UNITED STATES
NUCLEAR REGULATORY COMMISSION
WASHINGTON, D.C. 20555-0001

SAFETY EVALUATION REPORT

Docket No. 71-9342
Model No. Versa-Pac
Certificate of Compliance No. 71-9342
Revision 13

Figure 1: Versa-Pac Component (SAR Figure 1-1)

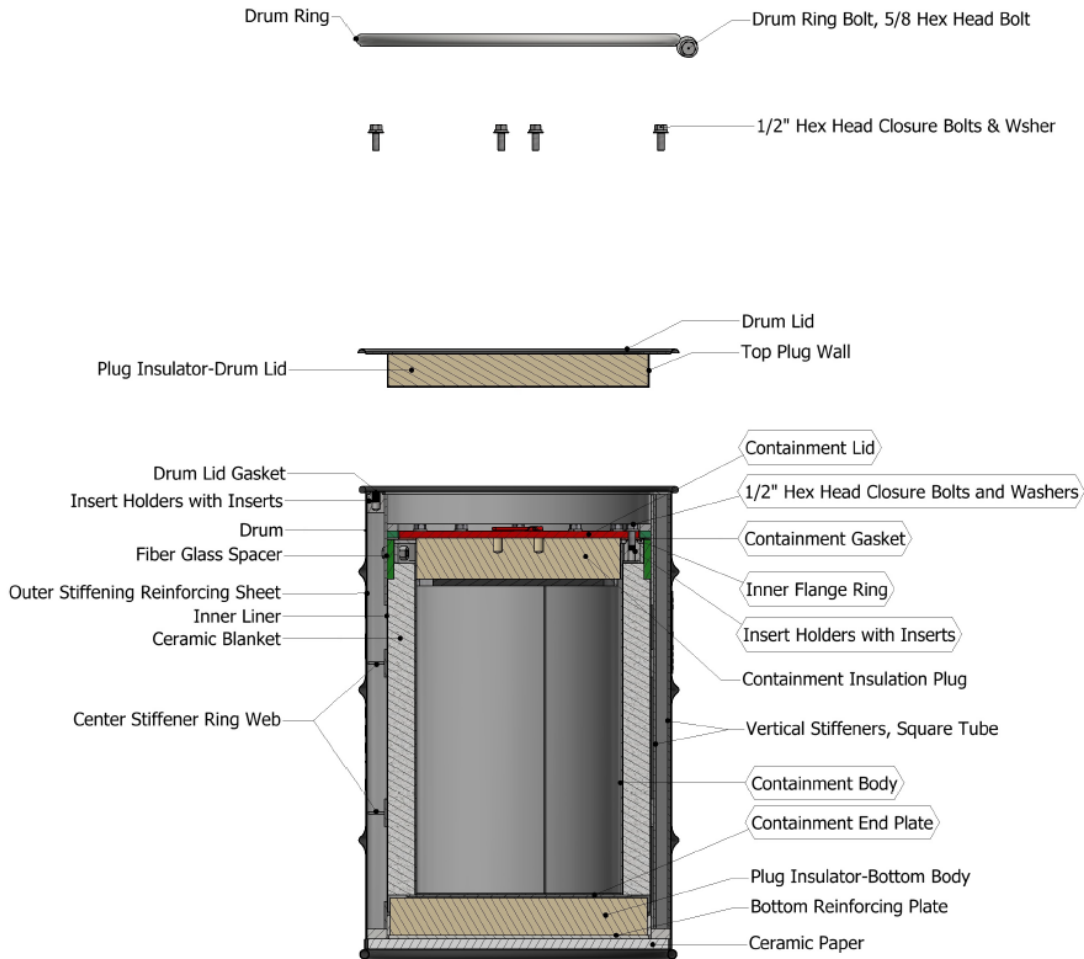
The containment boundary of the package is defined as the payload vessel with its associated welds, payload vessel high temperature heat resistant silicone coated fiberglass gasket, payload vessel blind flanges, and reinforcing ring. The payload vessel is comprised of a 10 gauge carbon steel sheet for the body and bottom. The upper end of the vessel is fitted with a 1/4-inch inner carbon steel flange ring with a 1/2-inch-thick carbon steel blind flange. The vessel has three circumferential welds (two at the flange, one at the base) and one longitudinal weld. A 1/8-inch high temperature, heat resistant silicone coated fiberglass gasket is used

between the steel flange ring and blind flange. The payload vessel blind flange is secured with twelve 1/2-inch bolts.

In addition to the above listed changes, the applicant requested removal of the term VP-55HC throughout the SAR and CoC for the use of the 5-inch pipe as a separate configuration of the VP-55 model.
